BCA ASSESSMENT REPORT

Bringelly Road Warehouse Facility
5 Skyline Crescent, Horningsea Park NSW 2171

Prepared for: ESR Developments (Australia) Pty Ltd | Issue date: 06 Apr 2022

DTS Clause	Description of Non-Compliance	Performance Requirement
C2.4	Requirements for open spaces and vehicular access	CP9

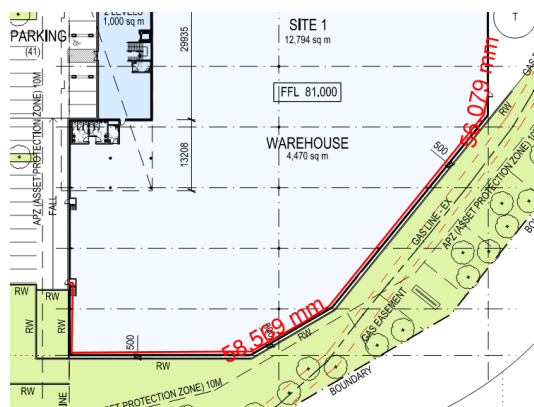
Access for emergency vehicles is not provided within 18m to the building to all elevations.

A Performance Solution addressing the Performance Requirement from a Certifier – Fire Safety is proposed to permit the non-continuous vehicular access.

D1.4 Extended travel distance to an exit

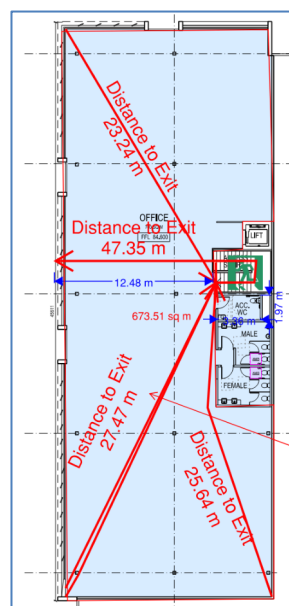
The Level 1 office portion requires occupants to travel up to 30m to a single exit in lieu of 20m.

Any future furniture layout is restricted to accommodate a travel distance of not more than 30m to the first noising of the egress stair.

A Performance Solution addressing the Performance Requirement from a Certifier – Fire Safety is proposed to permit the extended travel distances.

D3.5	Accessible Carparking
------	------------------------------

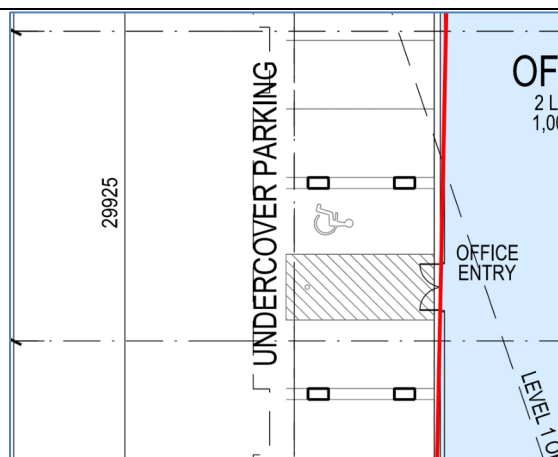
Dedicated accessible parking space to have a white symbol of access in accordance with AS1428.1-2009 between 800 and 1000mm high placed on a blue rectangle with no side more than 1200mm in the centre of the space between 500mm and 600mm from its entry point.

Hearing Augmentation

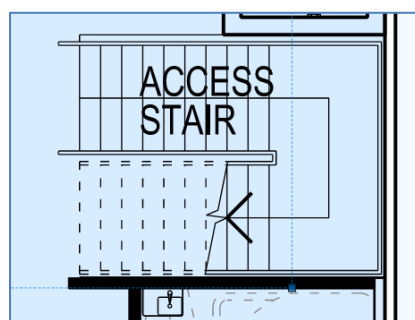
Hearing augmentation system to be provided for any meeting rooms within the office portion of the building that have an in-built amplification system.
